HP 9133/9134 D/H/L Service Manual

Manual part number: 5957-6560

Edition 2
E0488

Required Screws in Exchange Flexible

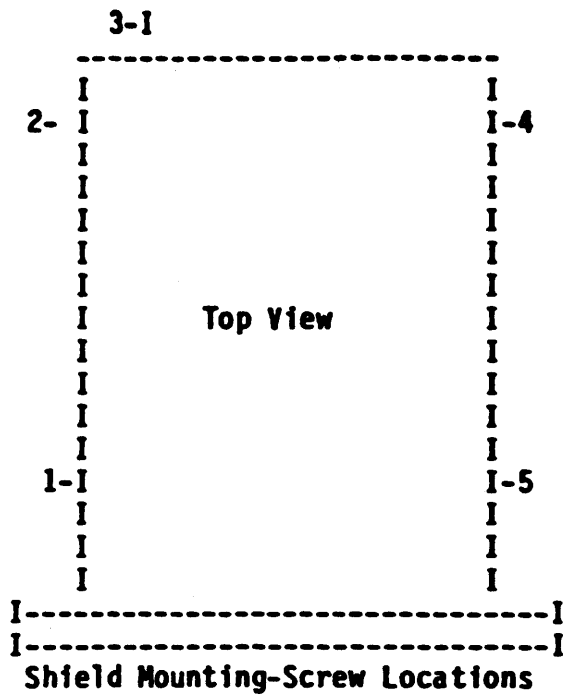
The 09114-69511 Flexible Disc drive is currently used in three products; the 9114A, the 9122D/S, and the 9133D. There are 5 possible locations for mounting-screws that attach the shield to the frame of the drive. Each product requires a different minimum number of screws. In some cases, screws must NOT be installed in certain locations.

All drives in the 9133D's have been shipped with the proper mounting-screws. However, many of the EXCHANGE drives shipped prior to September 1984 contained only the one rear mounting-screw. The exchange drive is now being shipped with the MAXIMUM number of screws to accommodate all products that use the drive.

The 9133D requires screws in locations 2 and 3 ONLY. Screws 1,4, and 5 MUST BE REMOVED.

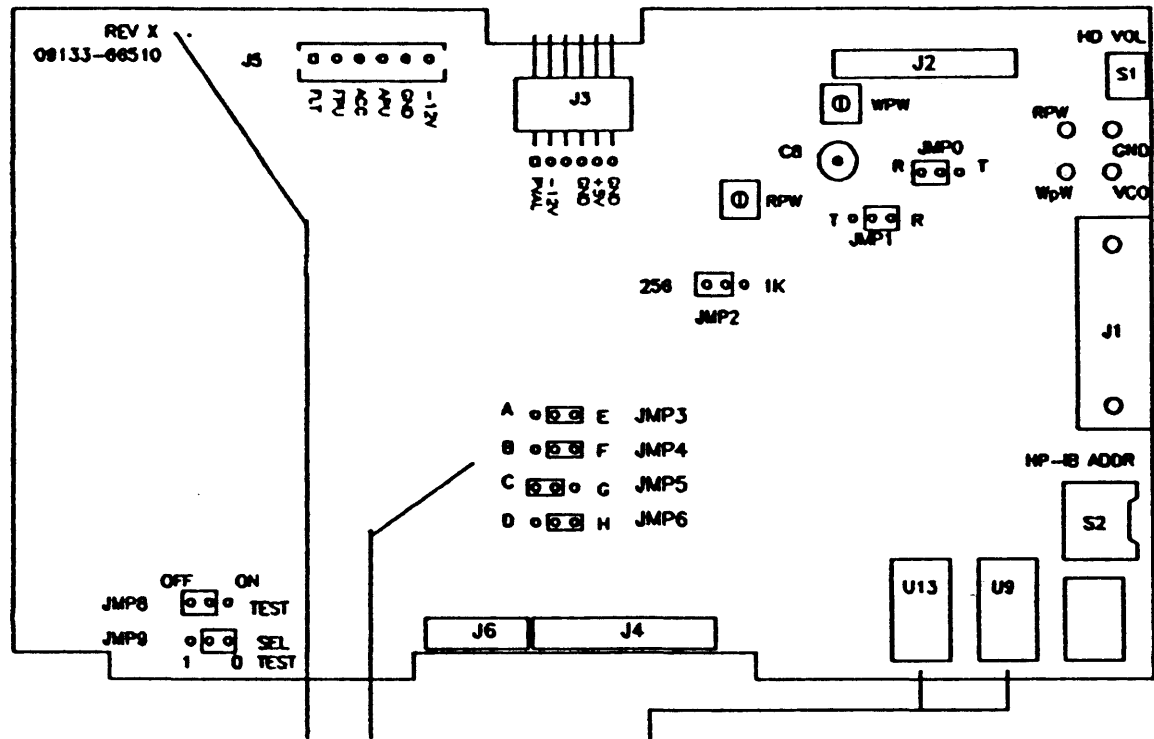
A revised controller PCA is being shipped in all 9133D Disc Drives. The new controller will be in 9133D products beginning at approximately serial number 2419A14750. This controller will also be shipped in all 9133D products with serial number prefix of 2511A and above.

The controller assembly has been revised to use a single IC to perform the hard disc controller and ECC functions which were previously performed by two IC's. Additional changes include a change to a different IC for the phase lock loop for the hard disc, and silkscreen changes to correct an error on the original PCA.

Both the Rev B and the Rev C controller assemblies will be used as exchange assembly 09133-69520. All service inventory of the original exchange assembly 09133-69510 must have firmware updated per service note 9133D-4 before being used to service any 9133D Disc Drives with serial number prefix 2511A or above. Firmware should not be updated in 9133D Disc Drives which are repaired.

Jumpers JMP3-JMP6 must be installed as shown in the figure on the next page to assure correct operation. Note that the jumper configurations shown here differ from those shown in the service documentation for the 9133D.

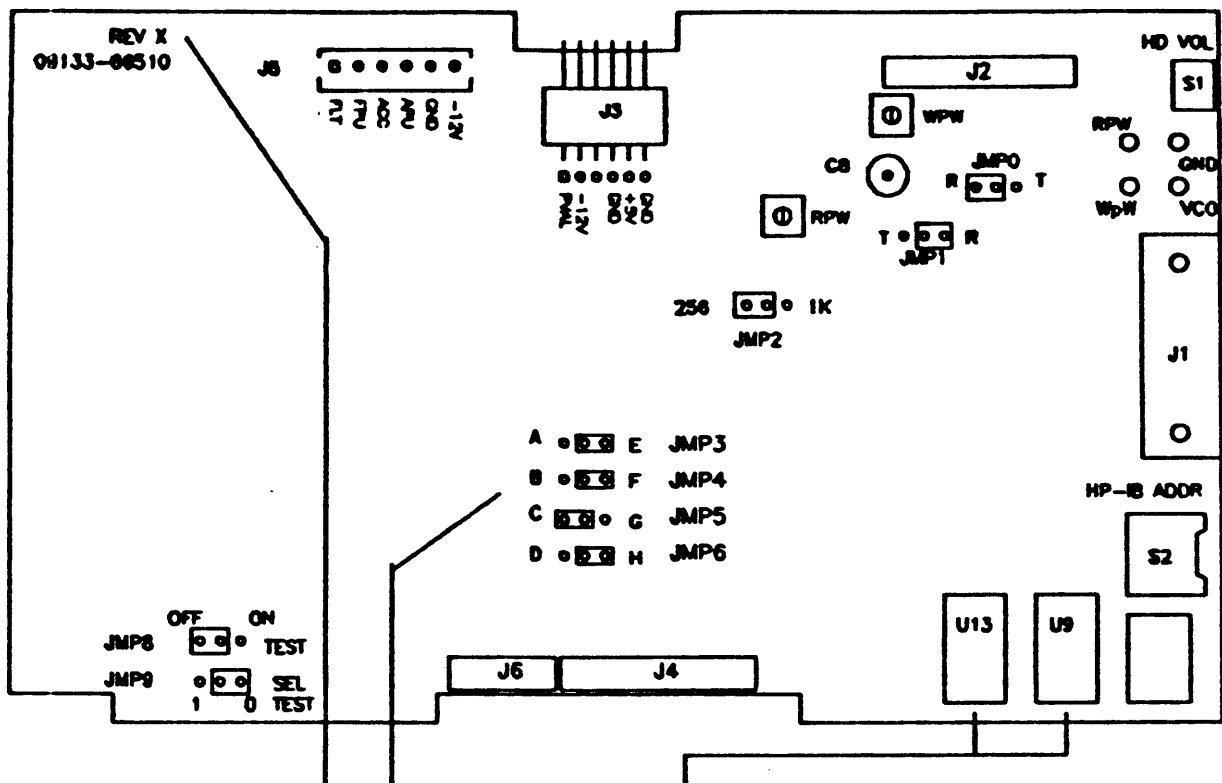
The 09133-69520 Controller PCA which is used in the 9133D, 9133H, 9134D, and 9134H may be a board which has '09133-66510 Rev B' or '09133-66510 Rev C' etched on the board. Jumpers JMP3-JMP6 must be configured properly for the product in which it is installed. Please note that the correct jumper configuration is determined by the product in which it is installed and the revision letter on the PC assembly.

Set JMP3-JMP6 as shown in the figure on the next page to assure that the jumpering is correct for the product in which the controller PCA is installed. Also note that JMP2 will have to be changed when a controller PCA is installed if the disc drive is option 001.

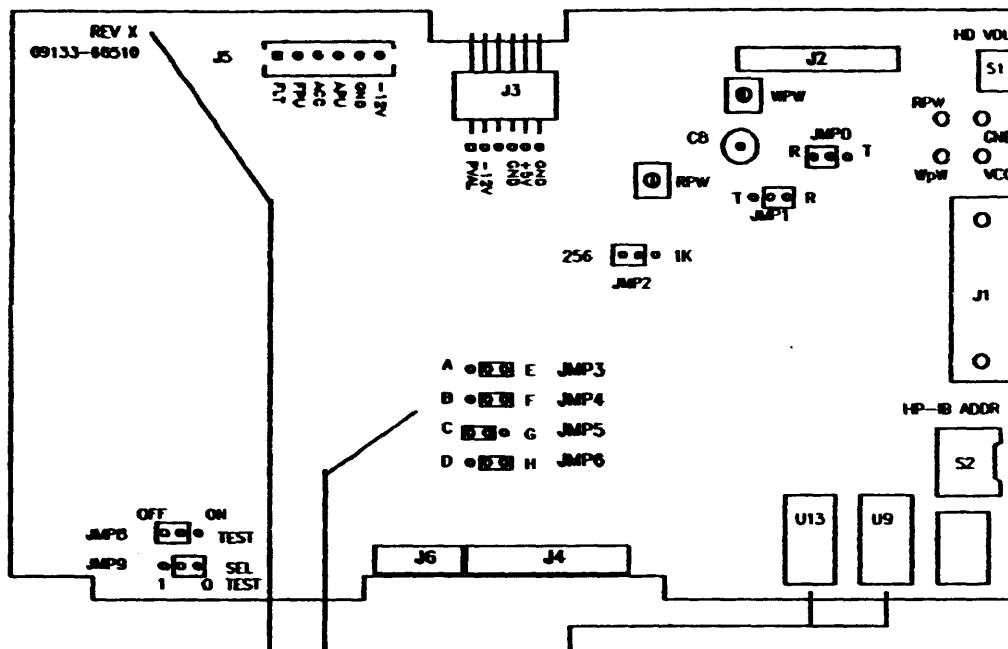
The 09133-69530 Controller PCA which is used in the 9133D, 9133H, 9133L, 9134D, 9134H, and 9134L may be a board which has '09133-66510 Rev B' or '09133-66510 Rev C' etched on the board. The correct configuration of JMP3-JMP6 on the 09133-69530 is determined by the product in which it is installed and the revision letter on the PC assembly.

Set JMP3-JMP6 as shown in the figure on the next page to assure that the jumpering is correct for the product in which the controller PCA is installed.

Note that if the revision letter on a controller PCA which is being replaced is not the same as the revision letter on the controller PCA which is being installed, the jumpering on the two PCA's will not be the same.

Also note that JMP2 will have to be changed when a controller PCA is installed if the disc drive is option 001.
